Access Compliance Report

Public Rights-of-Way

(Curb Ramps)

Intersection ID: 2513	Main Street: BENTGRASS_RUN_DR	Cross Street: COPPERMINE_LN	Location: SE
ADA ID: 0F1A393BE44C	Ramp Type: PerpDiag	Initial Pass/Fail: Pass	Overall Compliance: No
		Severity Score: 15

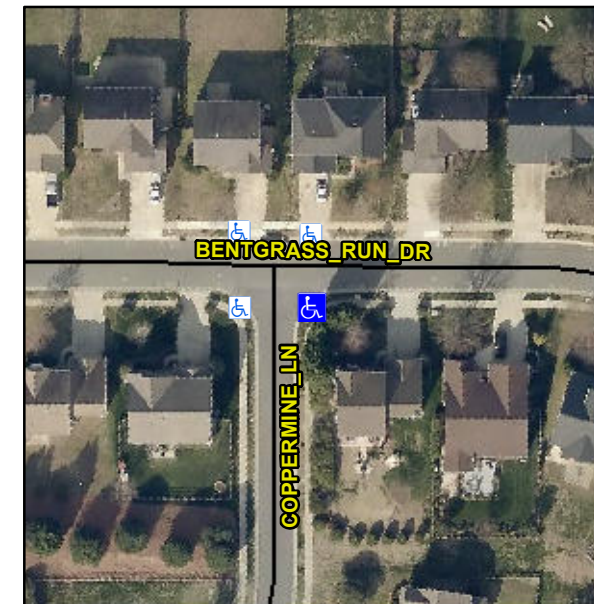
R304.2.2-Perp, R304.3.2-Para, R304.5.3, R305, R304.5.4

Remove & Replace Curb Ramp With Two New Directional Ramps or Equivalent. Remove & Replace Gutter.
